<b>SERVICE BULLETIN</b>		No.: MSB-98E00-001	
		Date: 1998-05-15	<Model> <M/Y>
<b>Subject:</b> YEAR MODEL CHANGES FOR '98 MODEL LANCER WAGON		(EC,EXP) LANCER HATCHBACK	98-10
<b>Group:</b> GENERAL		<b>Draftno:</b> 97-TA-012 (CBOV)	
<b>INFORMATION</b>	OVERSEAS SERVICE DEPT	<i>R. Usami</i> R. USAMI - MANAGER QUALITY INFORMATION ANALYSIS

This Service Bulletin informs you of year model changes for the 1998 model Lancer Wagon.

## WORKSHOP MANUAL SUPPLEMENT

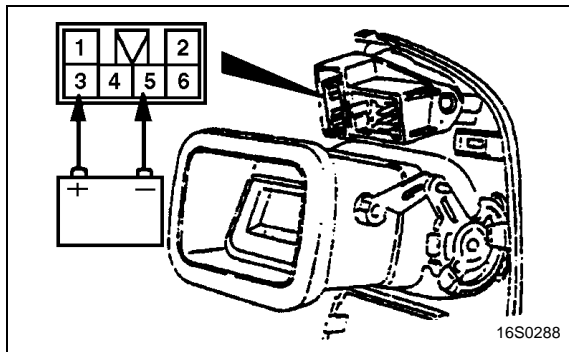
- With deletion of the dim-dip lamp, dim-dip lamp relays (1), (2), (3) and the resistor have been deleted. <RH drive vehicles>
- With change in lighting conditions for the rear fog lamp, the internal circuit for the rear fog lamp switch has been changed. Accordingly, the service procedures for the rear fog lamp switch have been established as described below. No difference exist except for the following.

- (1) Deletion of Dim-dip Lamps Relays (1), (2), (3) and Resistor
- (2) Change in Lighting Conditions for Rear Fog Lamp.

With the headlamps coming on, when the rear fog lamp switch is turned On, the rear fog lamp comes on, and when the rear fog lamp switch is again depressed, the rear fog lamp goes out.

When the headlamps go out, the rear fog lamp also goes out.
